# UNITED STATES PATENT AND TRADEMARK OFFICE

APPLICATION NO.	FILING DATE	FIRST NAMED INVENTOR	ATTORNEY DOCKET NO.	CONFIRMATION NO.
10/582,559	08/24/2006	Mathias Lutz	LUTZ, M.. ET AL-2 PCT	1580
25889	7590	05/12/2009	EXAMINER	
COLLARD & ROE, P.C. 1077 NORTHERN BOULEVARD ROSLYN, NY 11576			LOUDEN, CLIFFORD J	
		ART UNIT	PAPER NUMBER	
		3679		
		MAIL DATE	DELIVERY MODE	
		05/12/2009	PAPER

<b>Office Action Summary</b>	<b>Application No.</b>	<b>Applicant(s)</b>	
	10/582,559	LUTZ ET AL.	
	<b>Examiner</b>	<b>Art Unit</b>	
	CLIFFORD J. LOUDEN	3679

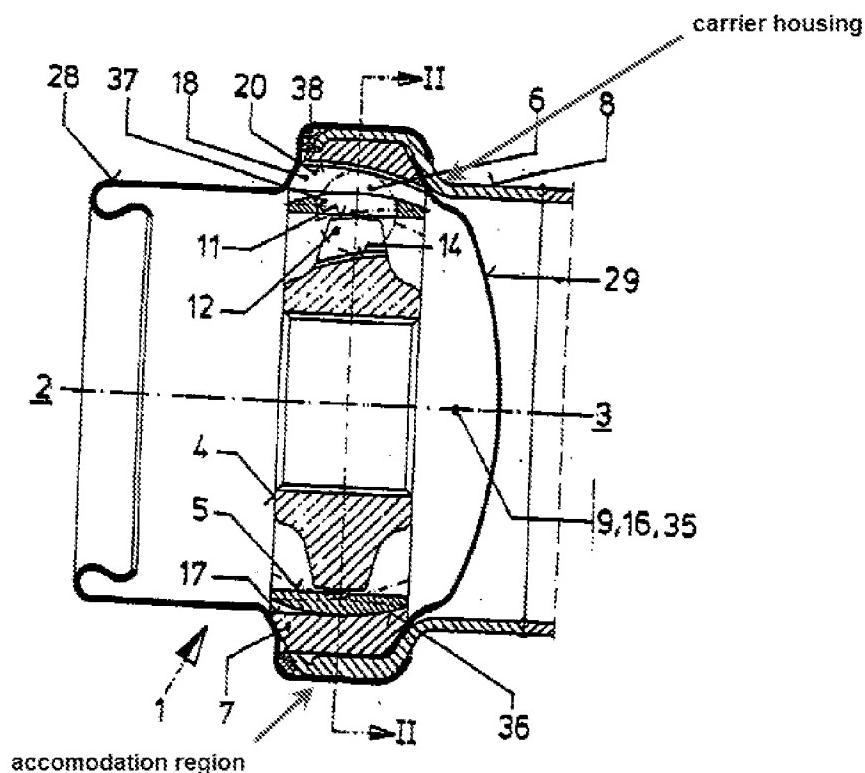
Claim 5: Jacob shows in Fig. 1 the inner hub (4) has an inner insertion gearing (i.e. splines) oriented coaxially to the axis of the inner hub, for accommodating an outer insertion gearing of one of the shaft sub-sections (inherent).

Claim 7: Jacob shows in Fig. 1 the joint (1) has a weld flange (8) for attachment to at least one of the shaft sub-sections on its drive-side and/or power-take-off-side end.

Claim 8: Jacob shows in Fig. 1 the outer hub (7) has a carrier housing having an accommodation region for the outer hub assigned to it, and that a lid (29) is wedged in between the accommodation region for the outer hub and the weld flange, on the inside of the carrier housing.

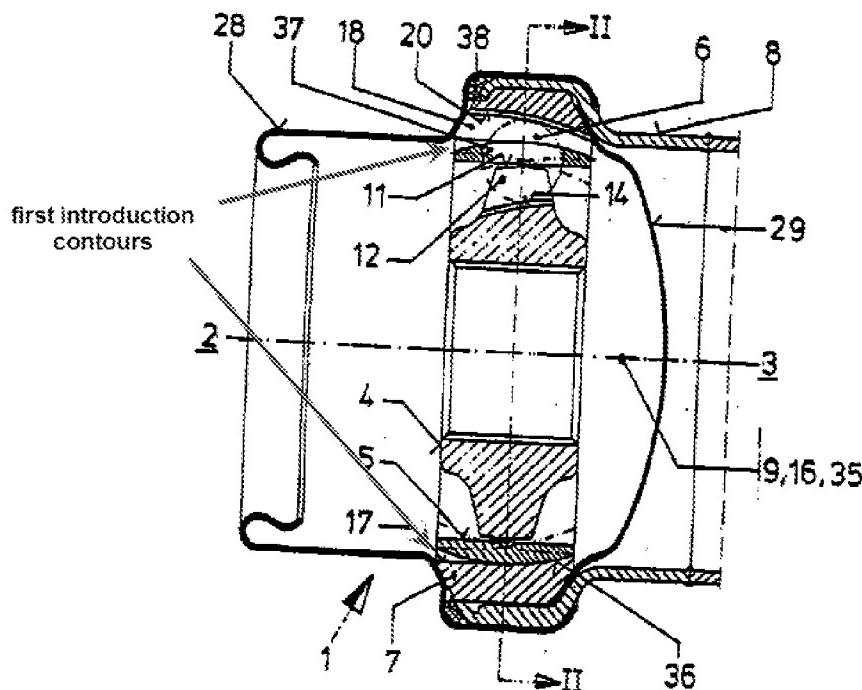
take-off-side end, at a diameter that at least approximately corresponds to the outside diameter of the cage, at least approximately after half the axial length of the outer hub, into second cage centering surfaces that run at an incline in the direction of the cage axis, and are configured to be ball-shaped, in accordance with the spherically shaped contact surfaces of the cage, whereby centering of the cage takes place exclusively in the outer hub (via first cage centering surface 22 & second cage centering surface 23), and centering of the inner hub relative to the outer hub takes place exclusively by way of the balls (see Fig. 1).

Claim 10: Jacob shows in Fig. 1 at least the contour of the second inner running grooves (13), and/or the contour of the first cage centering surfaces of the outer hub (7), and/or the contour of the spherical outer surface of the cage, and/or the elasticity of the outer

hub, are coordinated with one another in such a way that radial widening is made possible at least in the region of the second outer running grooves, by way of the balls (6) of the second row that are displaced radially outward (inherent given a sufficient force vector).
